SERVICE NOTE

E1405A C-Size VXI Command Module E1405B C-Size VXI Command Module

Modification to allow an E1405A/B to work with the HP 75000 Series 90 Modular SONET/SDH Analyzer VXI Systems.

Figure 1

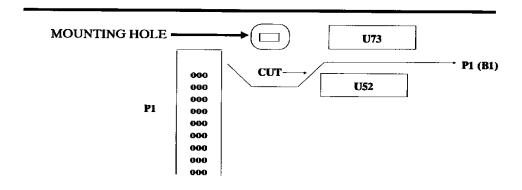
A modification of the E1405A/B Command Module will allow it to work with the Series 90 Systems. The modification described in this service note should only be performed on E1405A/B Command Modules that contain motherboards (part number E1405-66501) that are Revision C or greater and that have an Engineering Revision Code (ERC) of less than 3217. Motherboards with an ERC equal to 3217 or greater have been modified at the factory.
